ITB Title: Design, Supply and Installation of Pre-Engineered Steel Building for PW Garage

ITB#: 09-2025

Addendum #: 01

Issue Date of this Addendum: Sep 03, 2025

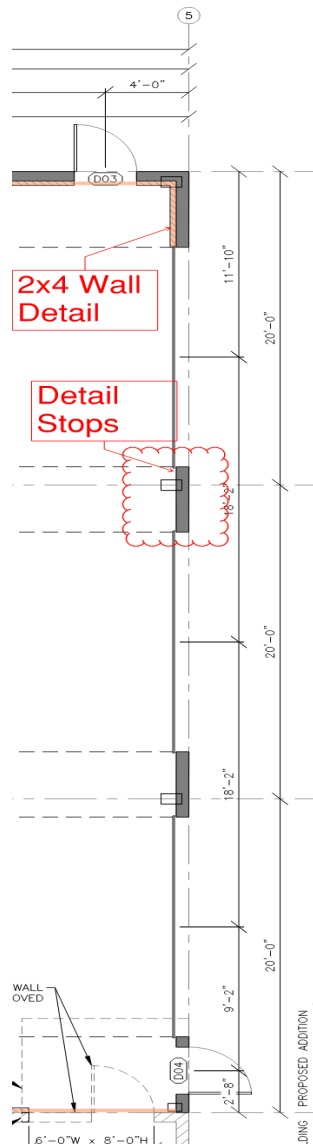
Question1: BC3 Notes 2x4 perimeter walls around the perimeter walls. Are they to continue around the entire perimeter?

Question 2: Drawing BC1 shows the 2x4 wall stops on gridline 5. Is that correct?

Answer 1: The 2x4 walls to be provided only where shown on the main floor plan. Locations are shown

on the main floor plan.

Answer 2: The 2x4 interior wall would end at the north side of overhead door “D10” and west side of the new opening to be cut in the existing building wall.
